# ***City of Albuquerque***

RE: **Grading and Drainage Certification**  
**The Branch Law Firm Annex**  
**(H-13/D038) (1401 Rio Grande Blvd NW)**  
**Engineer's Stamp dated 4/7/2000**  
**Engineering Certification dated 12/28/2000**

RE: GRADING AND DRAINAGE PLAN FOR THE BRANCH LAW FIRM ANNEX -  
PARKING ADDITION (H-13/D038) ENGINEER'S STAMP DATED 4/7/00

Re: Site Plan submittal for building permit approval for The Branch Law Firm, 1401 Rio Grande Blvd. N.W., M.R.G.C.D. Map No. 35. (Zone Map H-13-Z), Architect's Stamp dated 4/6/99.

SHEET  
**A1**  
OF 07

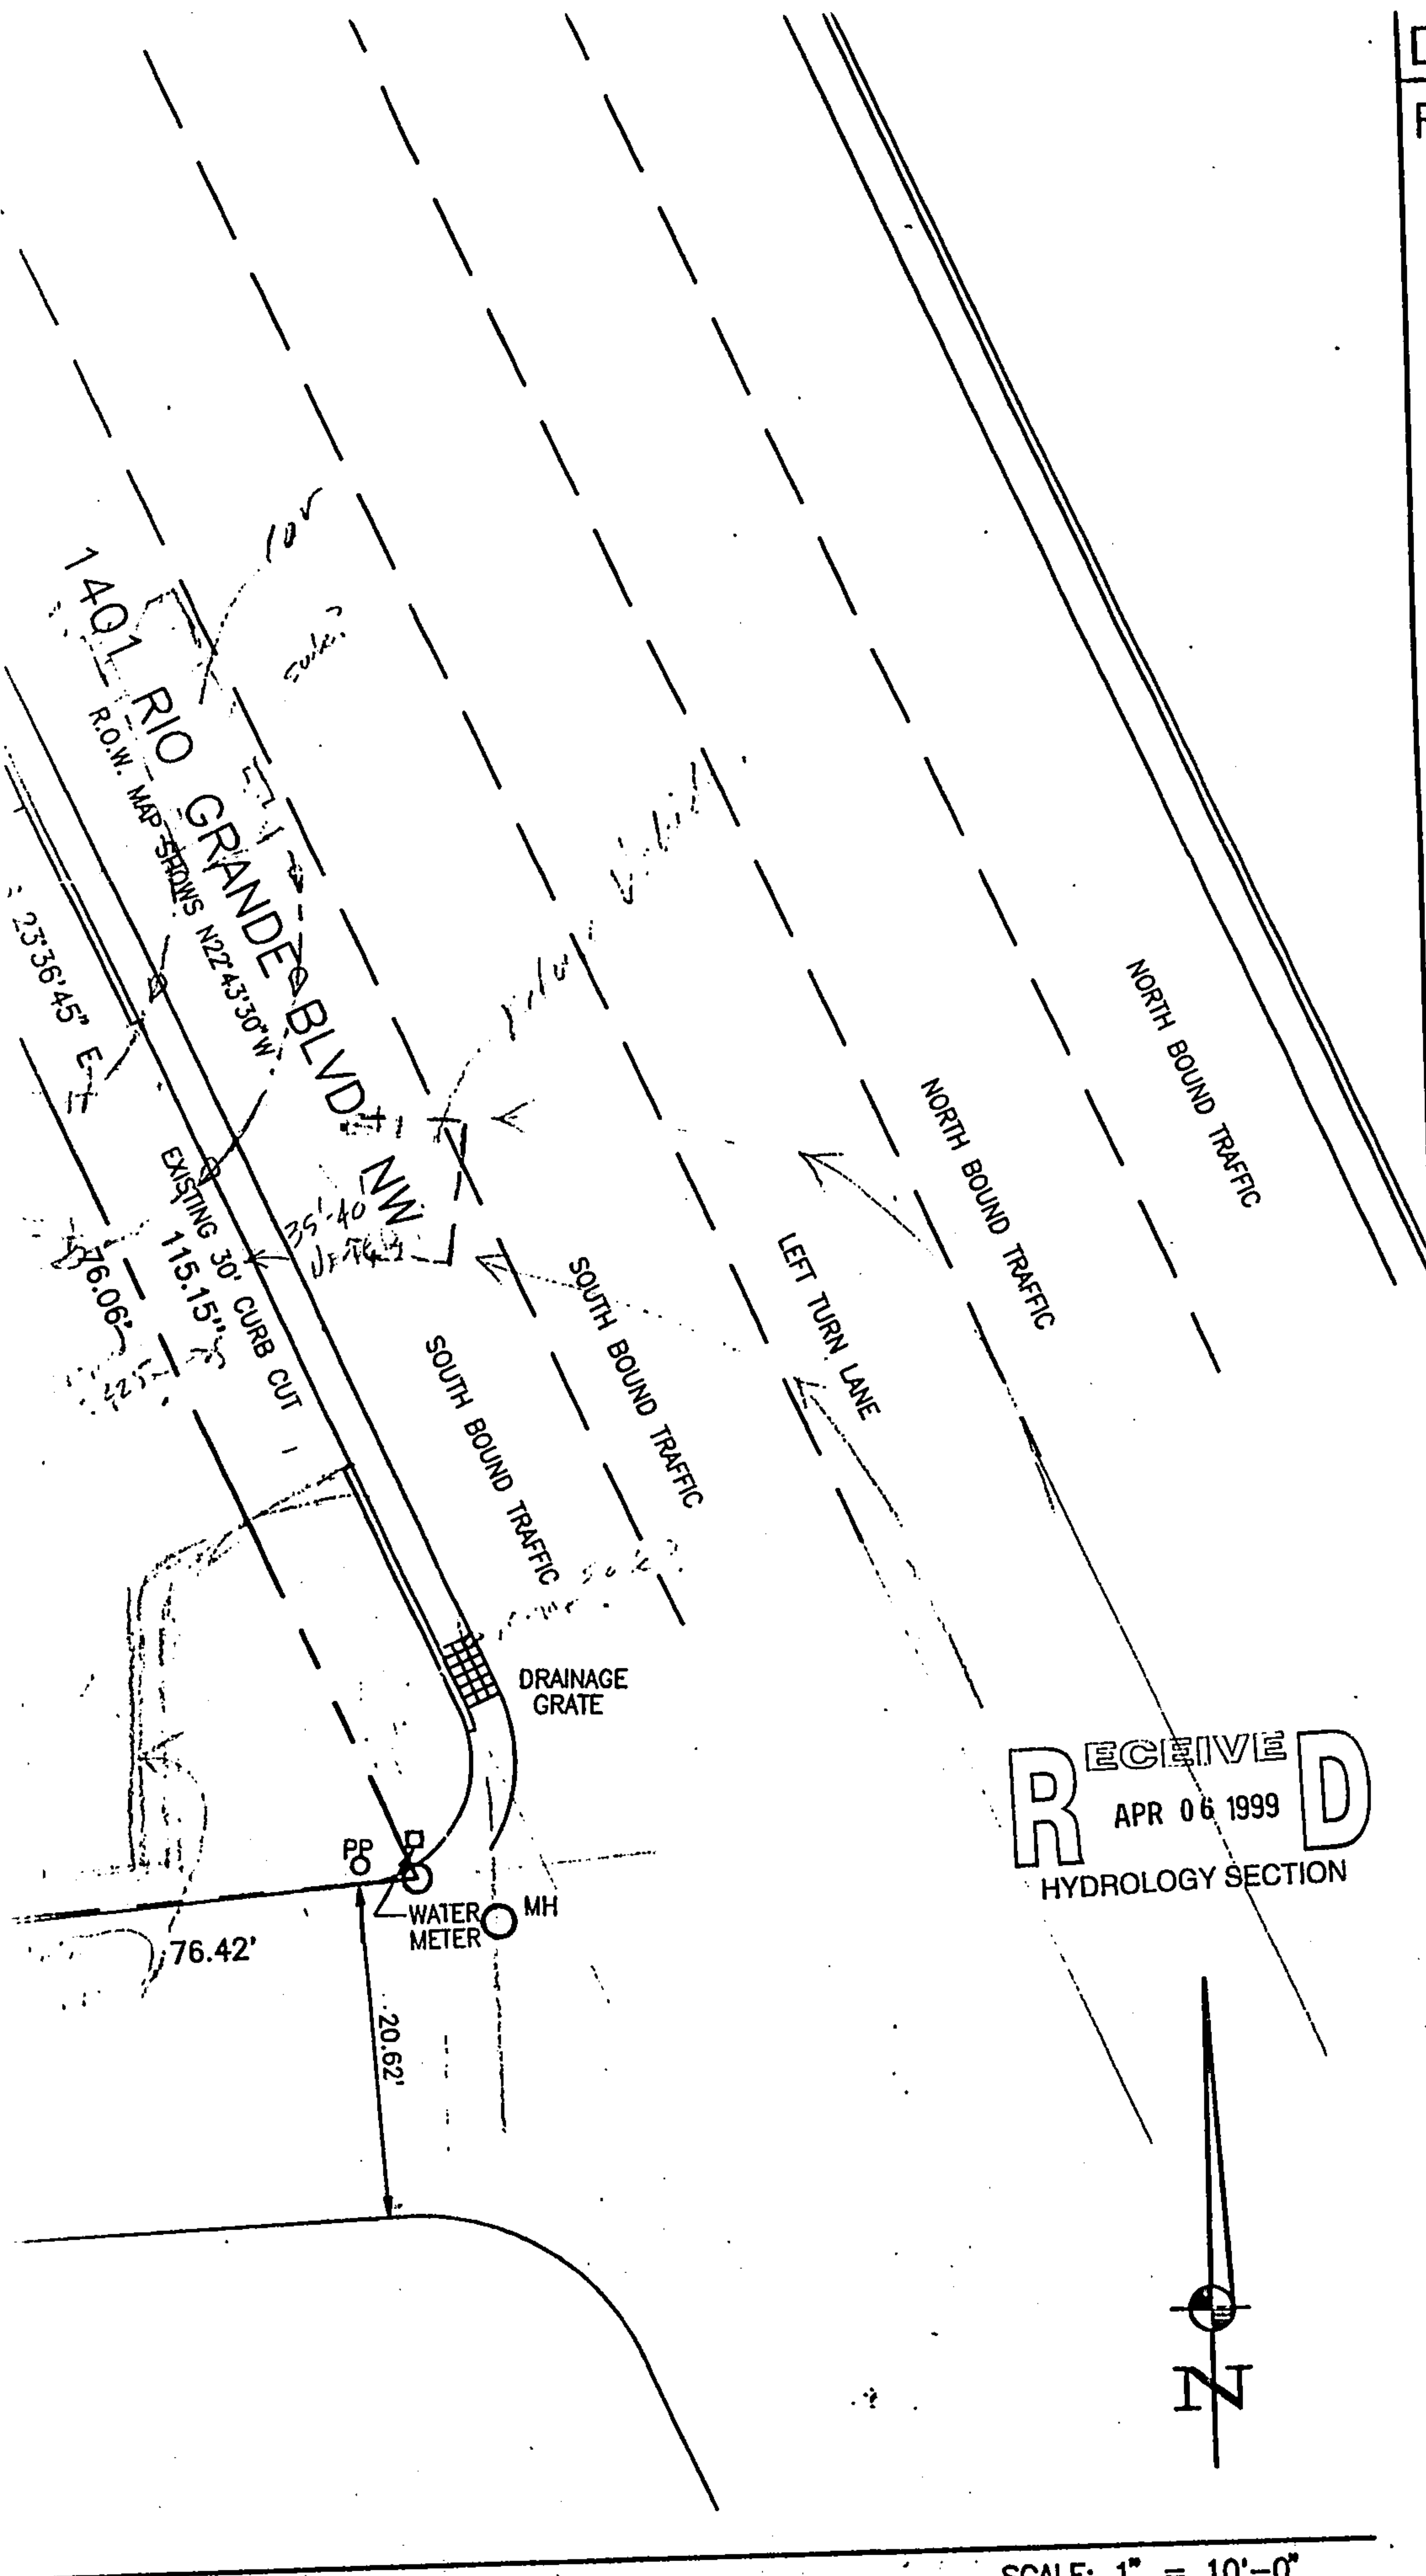
- 25' radius curve needed on end islands along large vehicle route as shown. Called out as 25' but shown as 15'. \_\_\_Minimum width of end islands-10'. . . . . \_\_\_Verification needed that Rio Grande Corridor Plan is being addressed.

- Copy of replat or current plat needed for office files, does not match latest Zone Atlas.
- New and existing elements noted on the Site Plan must be shown, labelled, and dimensioned correctly and accurately, this includes street edge of asphalt, limits of asphalt paving, all site sidewalks, street sidewalks and curb & gutter, all drive aisles, both driveways, any driveway of adjacent lot, if close to common property line, and any fencing (specifically at property lines), etc. \_\_\_Need to see clear differentiation between new construction and existing on Site Plan.

- Label - "Construct driveway per City of Albuquerque Std. Detail Dwg. No. 2425" and show correctly. \_\_\_If west edge of driveway is to be closer than 5'-6" to west property line approval from that lot owner is needed. . . . . \_\_\_Check keyed note 2/A1.

- Dimension stalls, label "typical" or call out in individual locations, if not typical. . . . . \_\_\_Call out to stripe lot per City Standard.
- Show, label, and dimension new street sidewalk on Rio Grande. City sidewalk ordinance requires minim. 6' concrete street sidewalk on Rio Grande. . . . . \_\_\_Show and label new HC ramp at street corner, must be A.D.A.

- Concrete curb needs to be constructed, per DPM Section 23.7 B6 (where needed and 4' minim. width landscape buffer), in parking lot adjacent to Rio Grande as shown and at south property line here; also at northeast corner of building as shown. \_\_\_Label detail-- "6" Header Curb Detail - Typical" or at each individual location \_\_\_If extruded concrete is used, top of surface of landscape mulching (gravel, bark, etc.) must be level with, or up to 1" below top of curb.

- Minim. 3' wide concrete walk needed across drive aisle from north row of parking, as shown to provide pedestrian access from parking. . . . . \_\_\_Stairs at north side of bldg. may be in pedestrian path from parking to entrance. Needs to be clear.

- HC ramp must be constructed at HC parking as part of sidewalk, as shown. \_\_\_Show ramp and slope of ramp using arrows.
- The curb cut may be left at 30 foot width, only if one-way traffic flow is maintained, which is required for this site to operate.

- Using traffic turning template, entrance from Rio Grande will not allow safe, effective use by standard car/pickup and refuse vehicle as shown. Existing parking layout accessed from Rio Grande cannot continue to be used since volumes of traffic are being increased. Layout will need to be rearranged, as shown or equal. This will include HC ramp construction and curbing construction here. Two options which will permit retaining two regular stalls and one HC stall, are shown. Option 1 will involve rebuilding sidewalk to be flush with asphalt, which can be worked in with HC access aisle. Option 2 will involve constructing ramp in existing sidewalk with minim. 8' wide HC access aisle. \_\_\_Remove stalls and wheelstops and diagonally hatch the area as shown. \_\_\_Minim. 20' wide drive aisle needed along service/emergency/refuse truck route [c.r.] \_\_\_Need to see confirmation of Fire and Solid Waste approvals regarding this.

- Need to see that all existing obstacles in City right-of-way, in existing sidewalks, have been picked up.
- All Civil Sheets (Drainage Plan, Site Plan and Landscape Plan) must be together at front of plan set.

Please provide revised Site Plan reflecting above requirements and copy of replat for my files. Also verification from stated sections is needed, including Zoning regarding Rio Grande Corridor. If you have questions please come by so I can clarify as necessary.
